Project:	<b>Highways England Spatial Planning Arrangement</b>	Job No: <b>60600479</b> <b>DM014.014</b>
Subject:	<b>South Caldecotte, Audit of revised forecast VISSIM model</b>	
Prepared by:	<b>Alejandro Pina Botella</b>	Date: <b>11/08/2020</b>
Checked by:	<b>Javier Pardo</b>	Date: <b>12/08/2020</b>
Verified by:	<b>Phil Arnold / Liz Judson</b>	Date: <b>13/08/2020</b>
Approved by:	<b>John Alderman</b>	Date: <b>13/08/2020</b>

This Technical Note (TN14) provides a summary of the audit of the revised forecast Vissim models (dated 30<sup>th</sup> June 2020) developed for the A5 Kelly's Kitchen Roundabout by BWB. The Vissim models have been prepared to support the planning application of an employment development at South Caldecotte in Milton Keynes.

Figure 2. Modelled journey times.

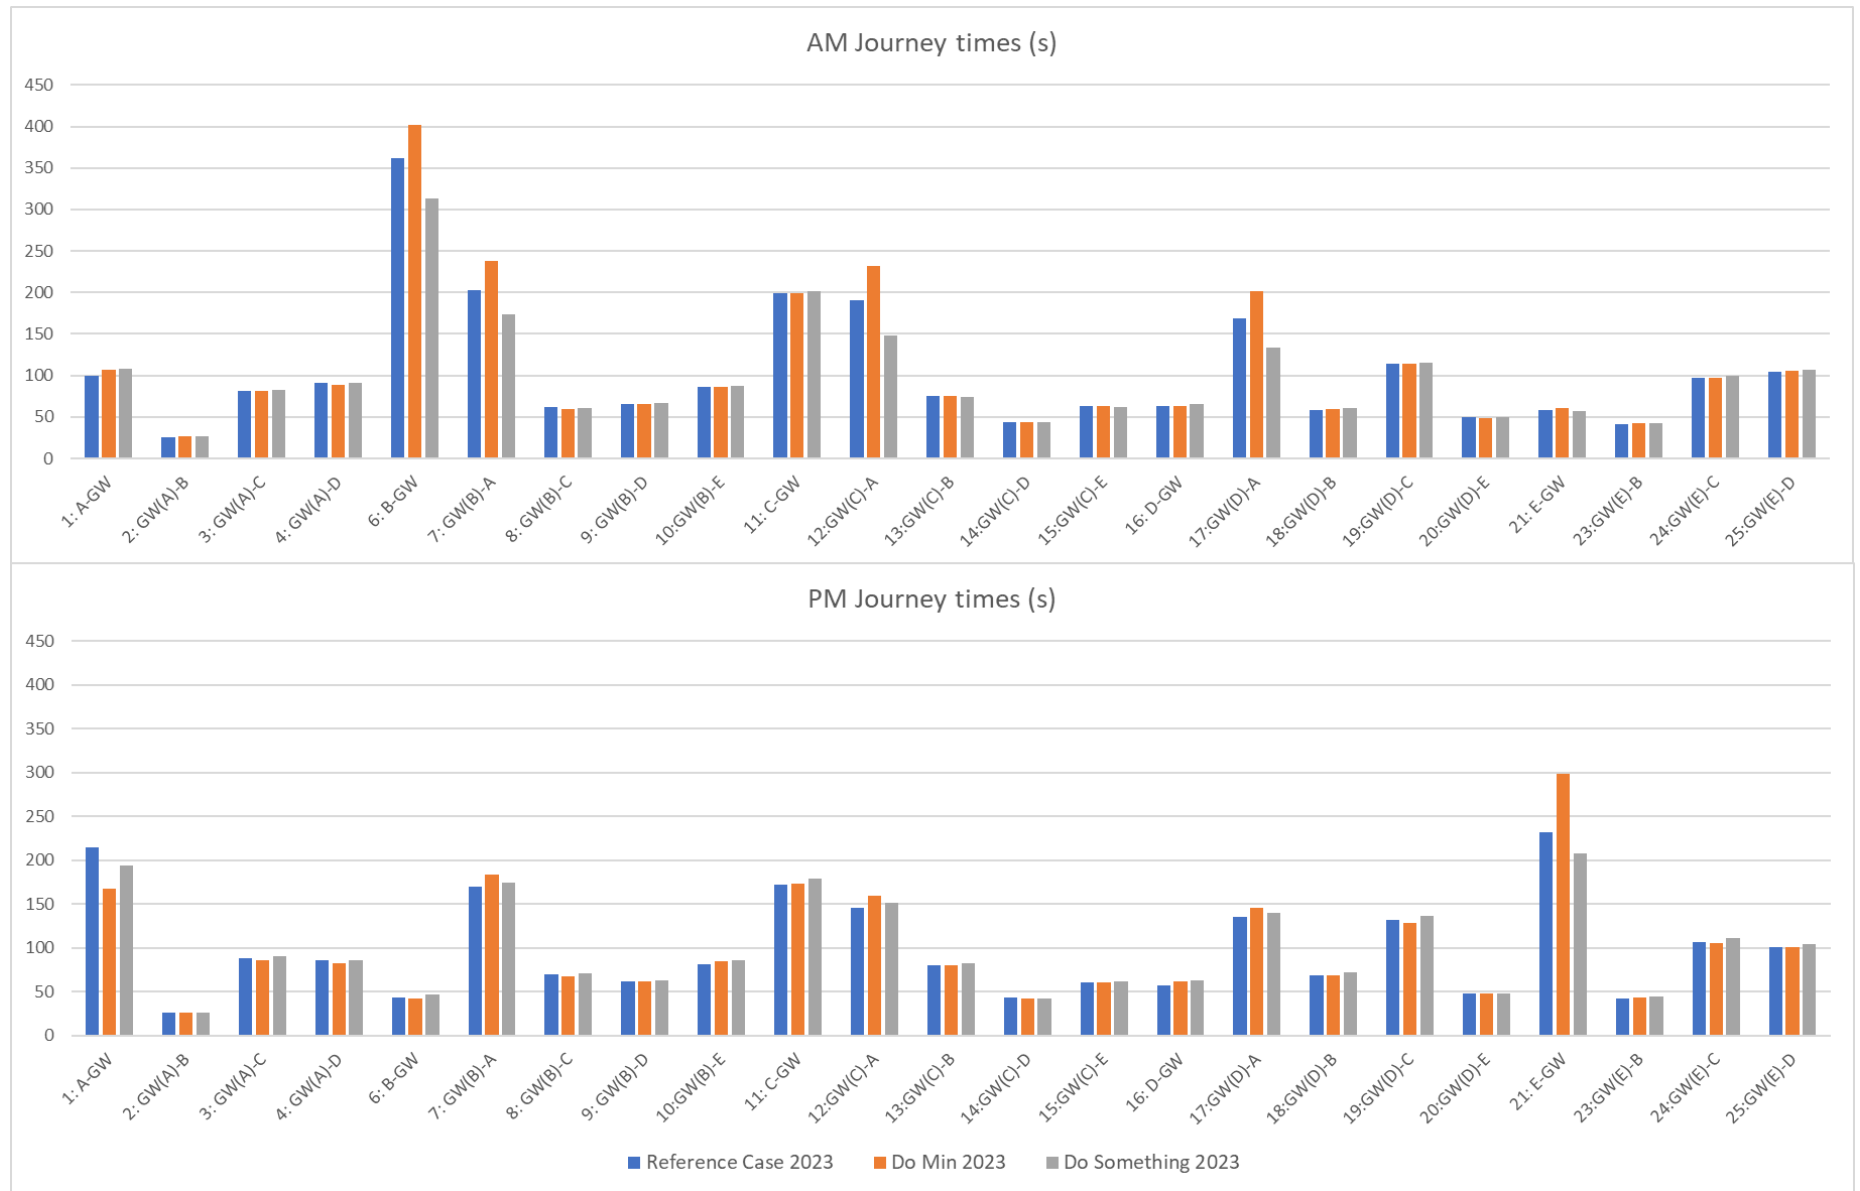
Figure 2 shows the journey time results for the AM and PM peak hours on all the approaches to the Kelly's Kitchen junction produced by the model submitted by BWB.

The journey time results for the AM peak hour show that:

- The proposed mitigation in the Do Something scenario offsets the increase in journey times seen from the Reference Case to Do Minimum (due to the additional development trips) on most approaches to the junction (B-GW, C-GW, D-GW and E-GW);
- There is a marginal increase of 9 seconds from the Reference Case scenario to the Do Something scenario on Brickhill Street southbound (A-GW);
- The implementation of the proposed mitigation results in significant reductions in journey times on Brickhill Street northbound (GW(B)-B, GW(C)-B and GW(D)-B) and on the A5 northbound (B-GW), so that the resulting journey times are lower than that of the Reference Case;

The journey time results for the PM peak hour show that:

- The additional northbound traffic on Brickhill Street (inbound trips into the development) in the Do Minimum scenario results in more green time being assigned to that movement across the junction, which benefits the southbound approach to the junction (A-GW), causing a significant increase in the journey time on the A5 southbound (E-GW);
- The implementation of the proposed mitigations in the Do Something scenario offsets the main increase in journey time caused by the development trips in the Do Minimum, i.e. the increase in journey times on the A5 southbound (E-GW) is effectively mitigated; and
- Journey times on all routes through the junction are generally either reduced or remain similar in the Do Something Scenario compared to the Reference Case, with only marginal increases seen on some movements.

**Figure 7. Network Performance results for total delay<sup>1</sup> including latent delay.**

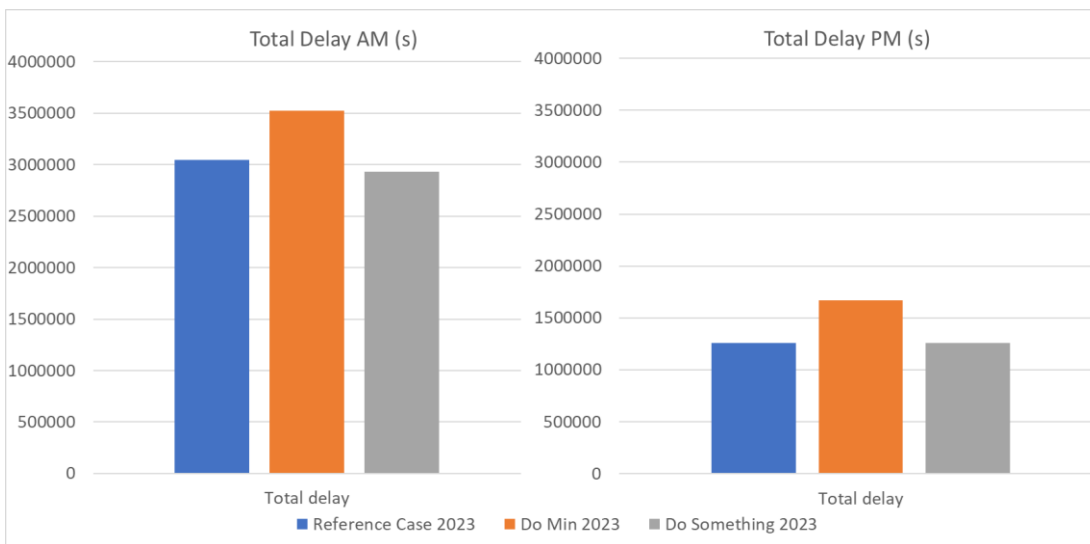
Table 3 and Figure 7 show the network performance results, as produced by the models submitted by BWB.

There is predicted to be a significant reduction in overall average delay and latent demand with the implementation of the proposed mitigations in the AM peak hour (comparison between Reference Case, Do Minimum and Do Something).

The Total Delay figures include both the delay experienced by all vehicles loaded in the network, and the delay experienced by vehicles that could not enter the network during the simulation. The results indicate that the additional delay caused by the development in the PM peak hour is effectively mitigated in the Do Something Scenario. The results also show that there is less overall delay in the Do Something scenarios compared to the Reference Case scenarios in the AM peak hour.

It should be noted however that this assessment includes the mitigation at the Tilbrook Roundabout. The latent demand indicates, that due to congestion, not all vehicles are able to enter the model network.
